FINAL
NAVAL AIR STATION ALAMEDA RESTORATION ADVISORY BOARD
MEETING SUMMARY

March 9, 2004

ATTACHMENT B-5
RESPONSES TO COMMENTS ON DRAFT OU-5 SOIL FS REPORT
(15 Pages)

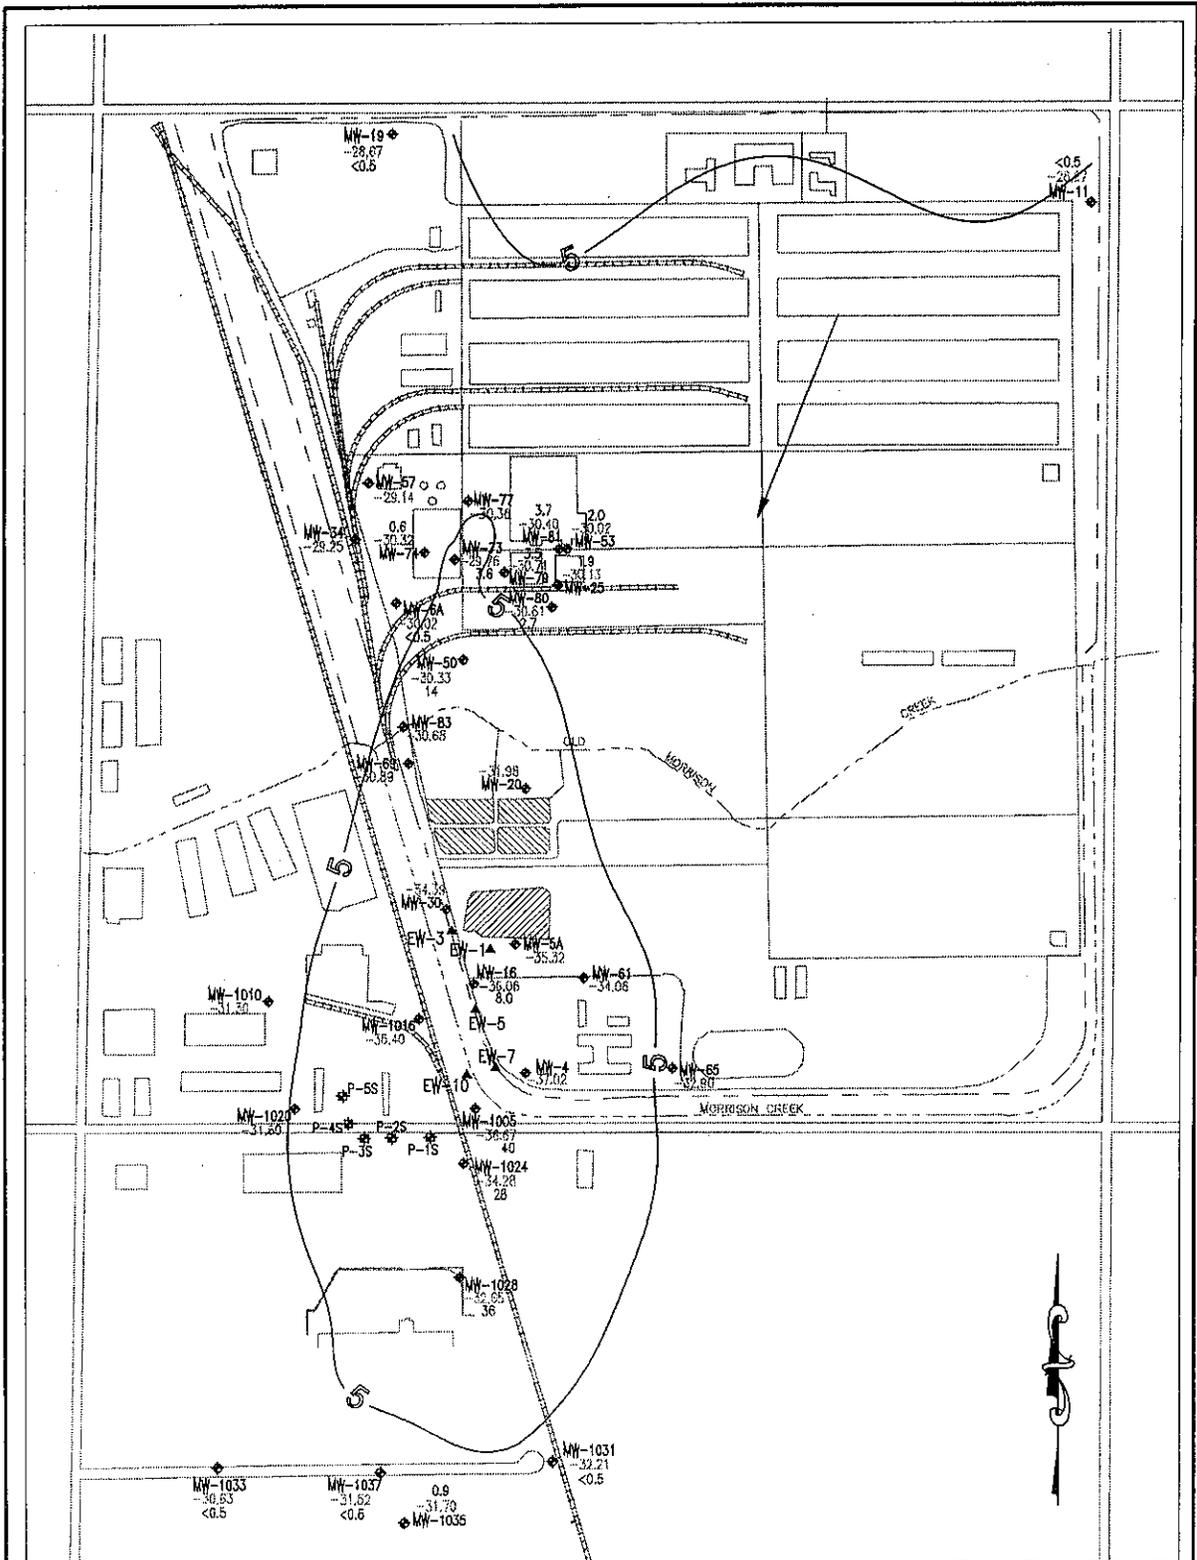
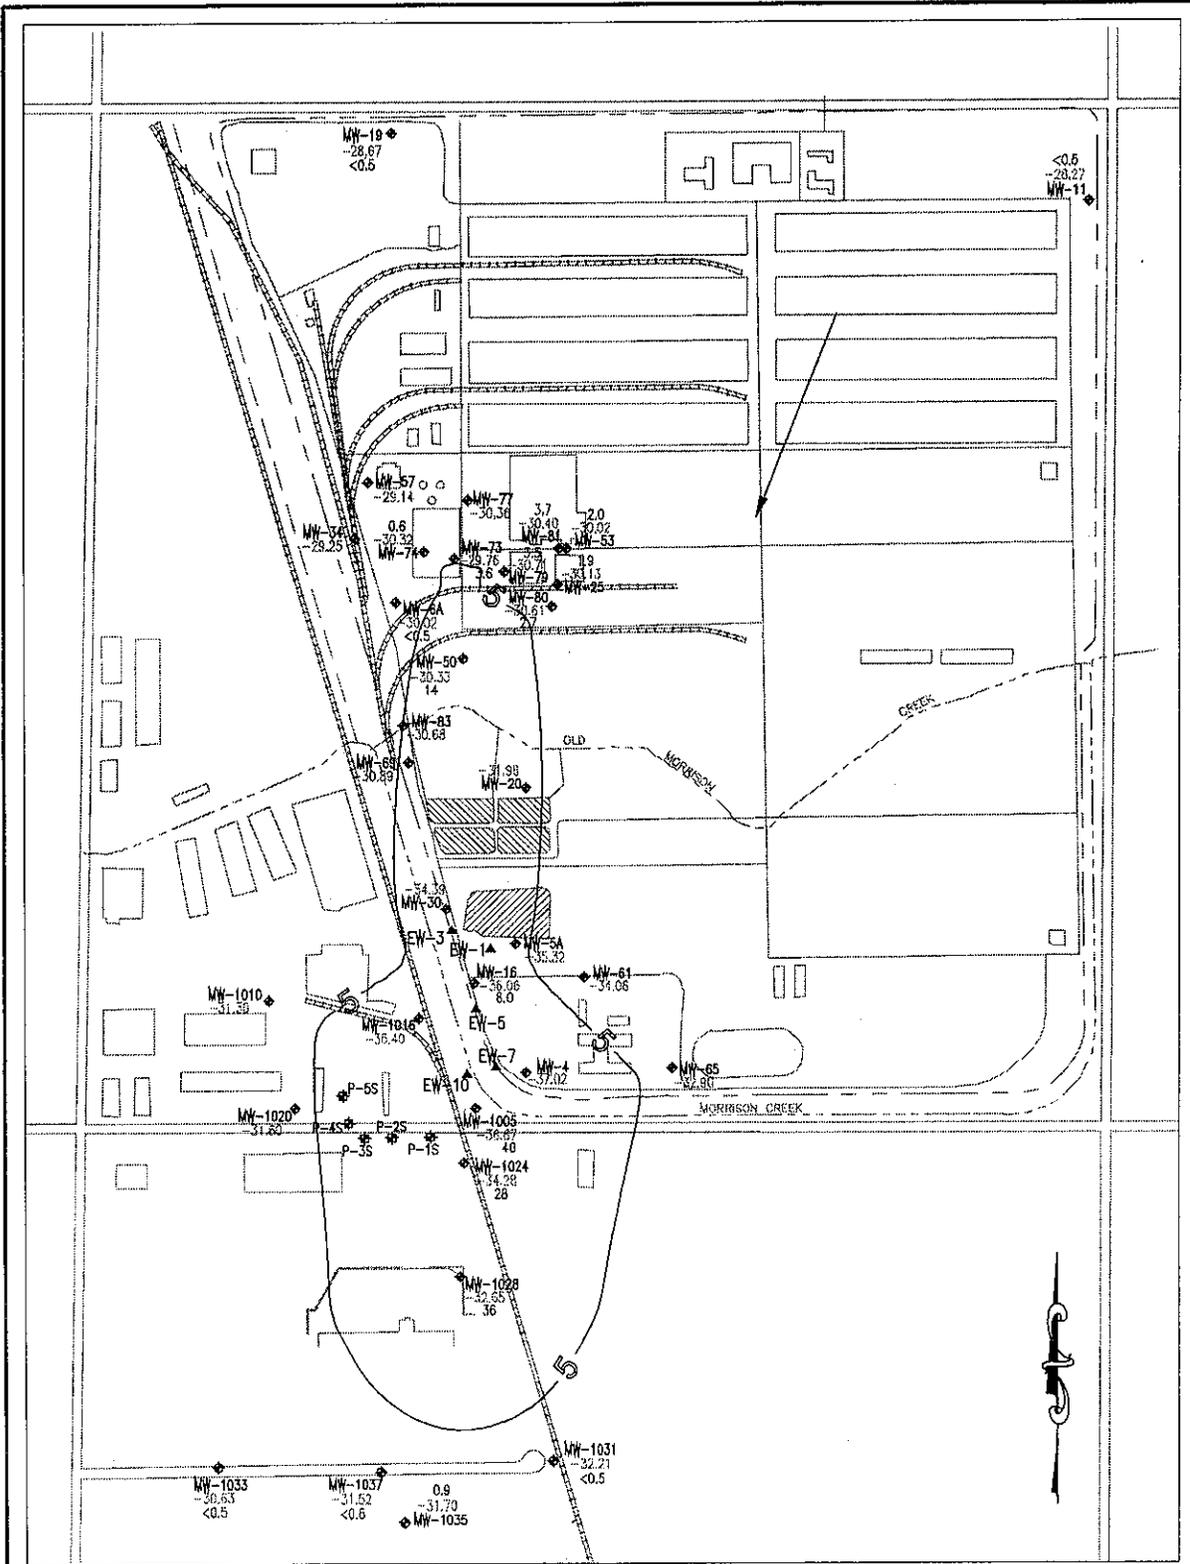
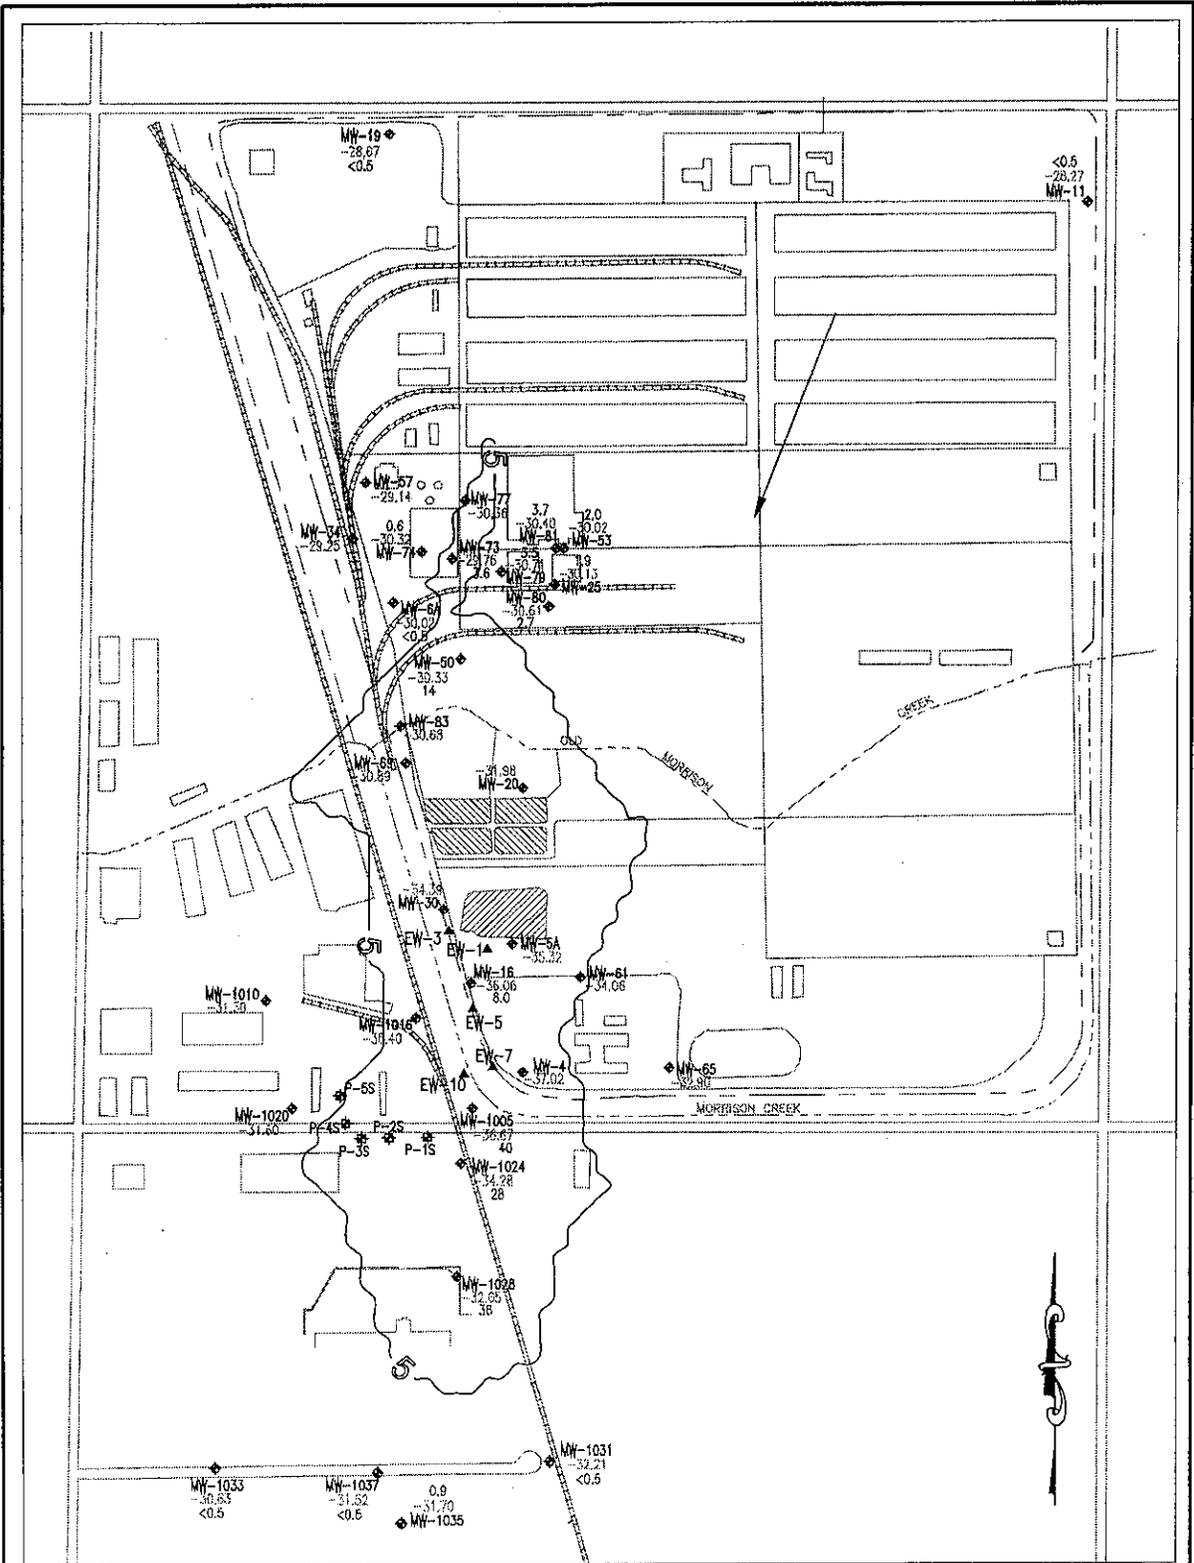
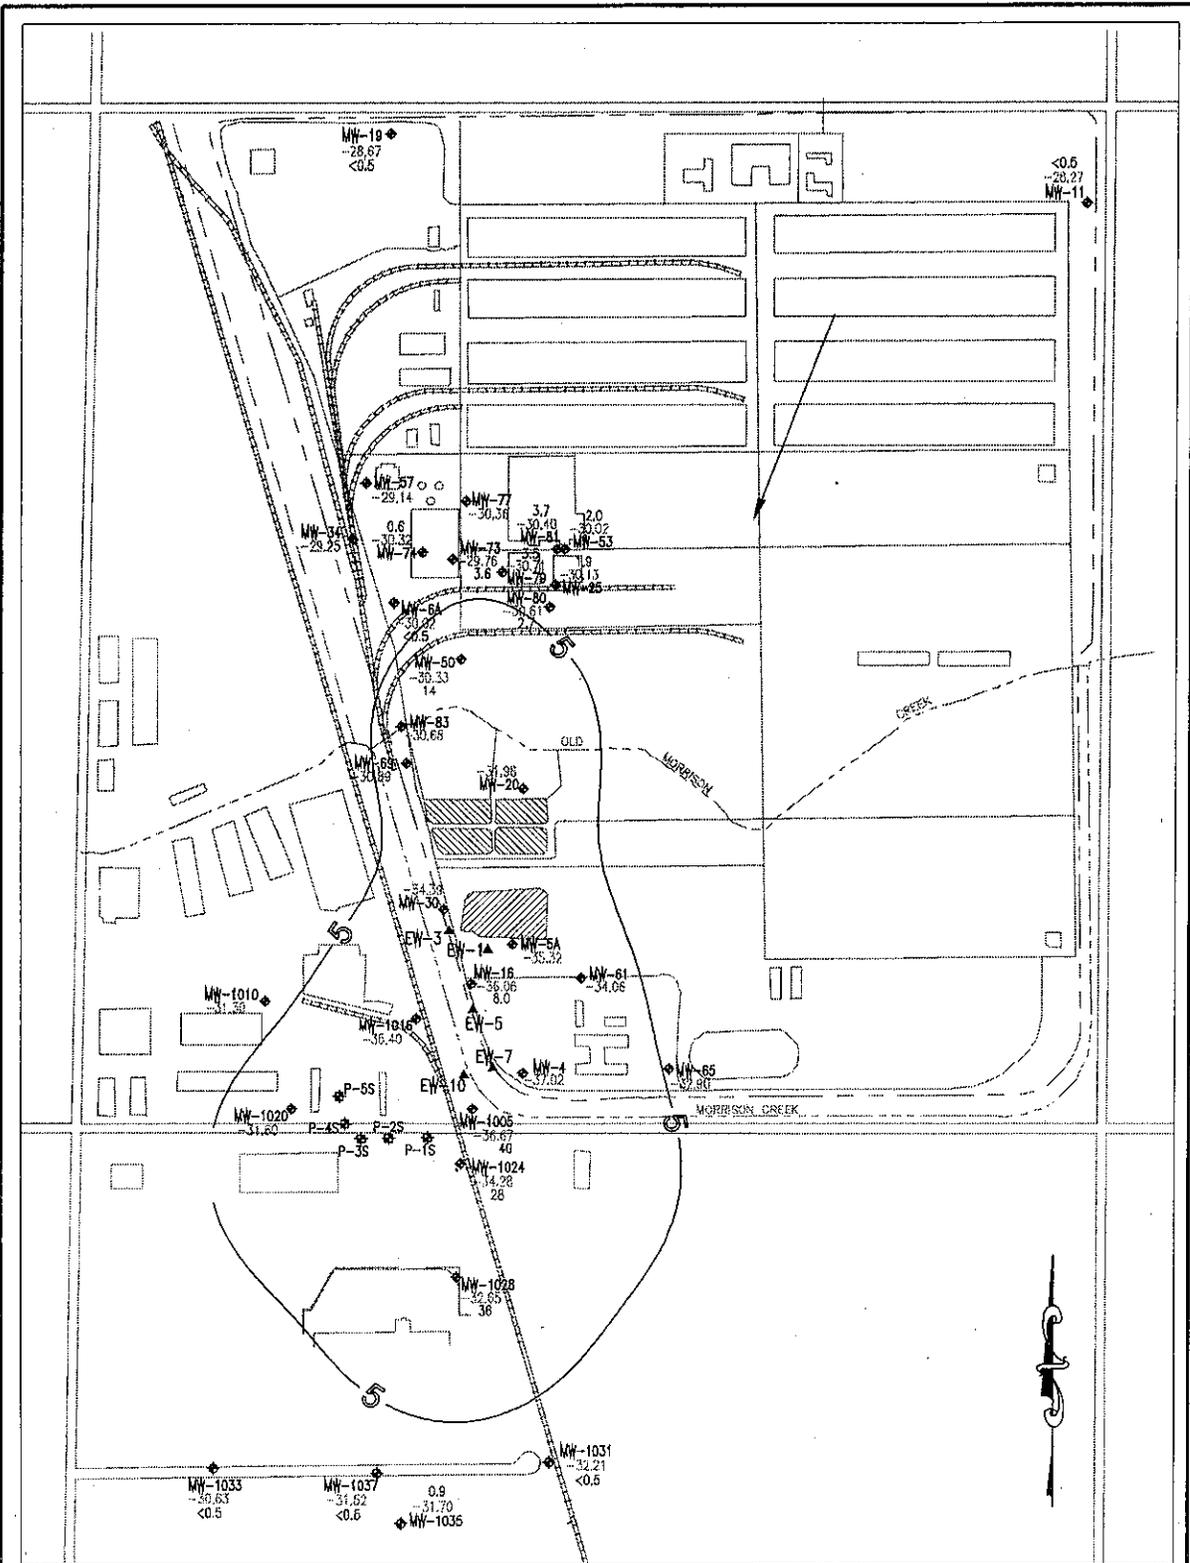
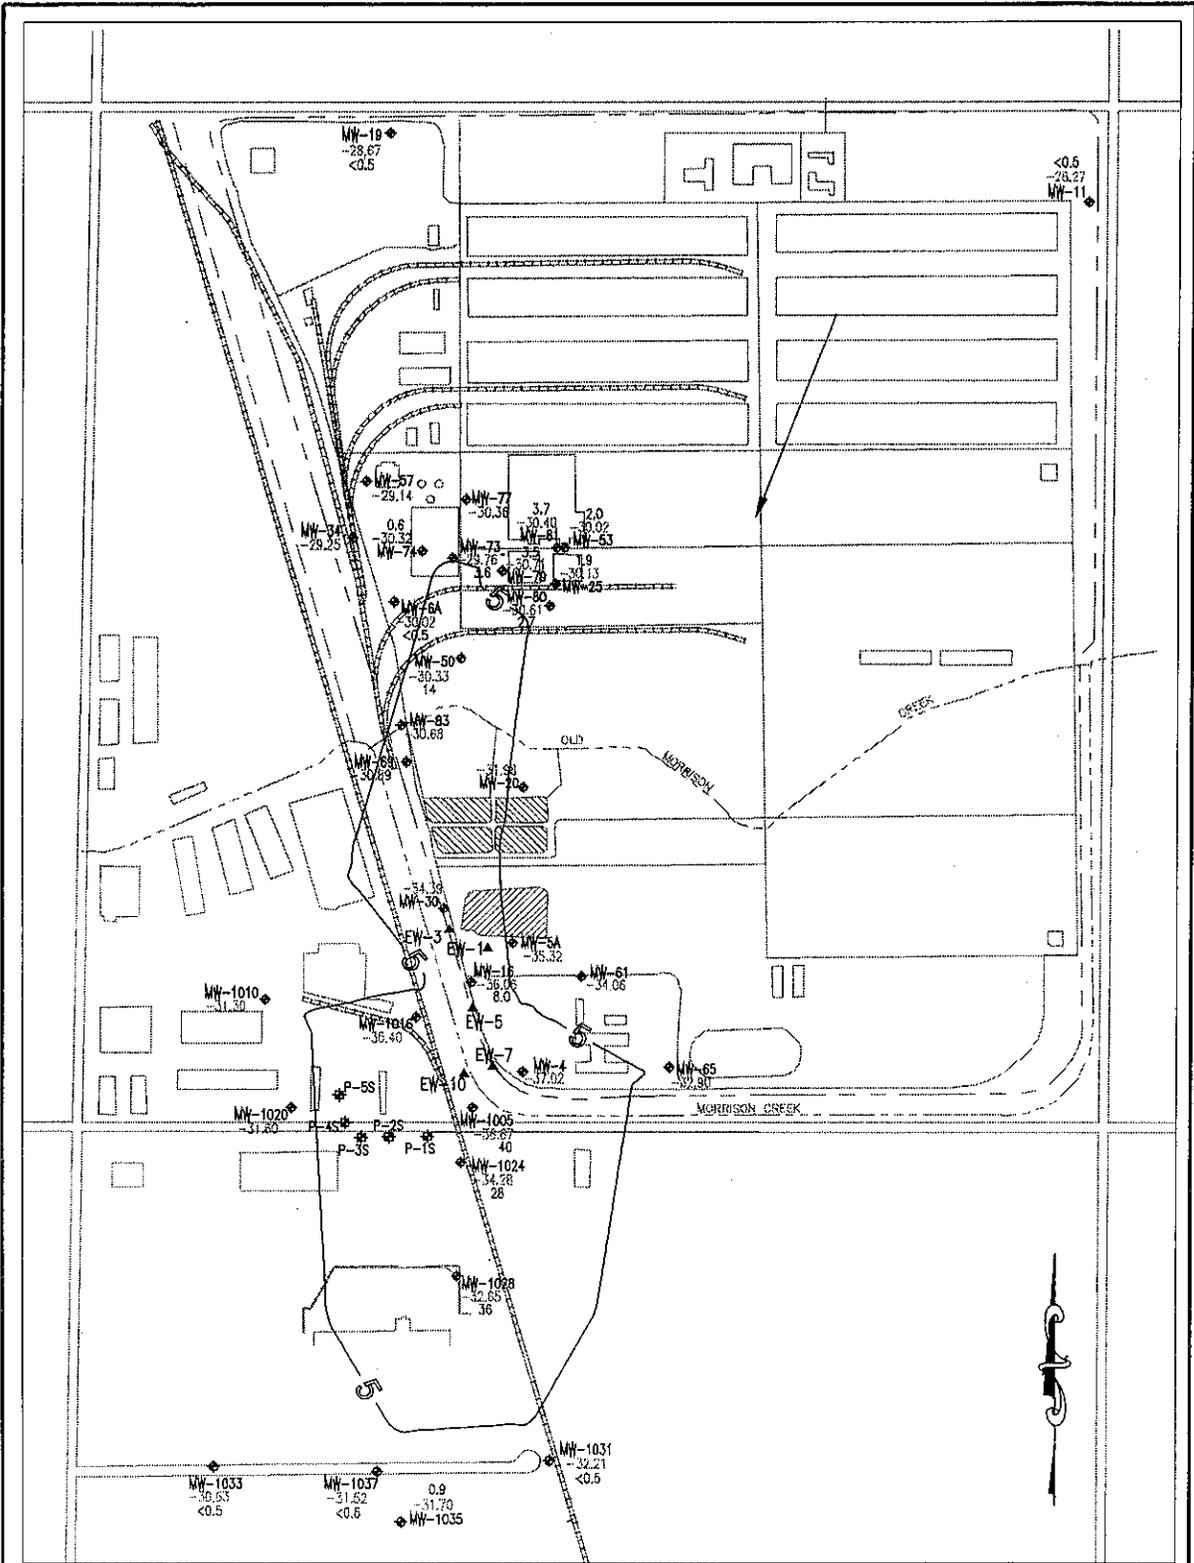
- The use of software programs like Surfer™ (a copyrighted software program) has made groundwater contouring for elevation and concentration much easier. However, Surfer™ does have limitations and numerous settings which must be taken into account when performing the contouring functions.
 - The handout has some examples of how contours can change at a site just from the different settings on Surfer™.

No.	Section	Page	Comment	Navy Response
4.	<i>Nature and Extent of Contamination</i>	4-3 and 4-4	<p>As a minor point, SURFER© is a trademarked name and should noted as such in the text.</p> <p>The use of this program is great in the environmental industry and this reviewer highly recommends it, but it does have limitations and human intervention (and some subjectivity) is often necessary. Judging from the contours drawn for the project, it seems that the program force-fitted some of the data points without regard to normal plume behavior. As a reference to other reviewers, it may be helpful to name the kriging technique that was chosen in the program to generate the contours (natural neighbor, kriging, log, etc.) and any anisotropy employed in the contouring. This reviewer believes that a more natural or accurate set of contours could be generated from the data by using the proper settings on the program and some intuitive (and subjective) judgment on the registered geologist's or engineer's part. This may also be helpful in identifying the source areas.</p>
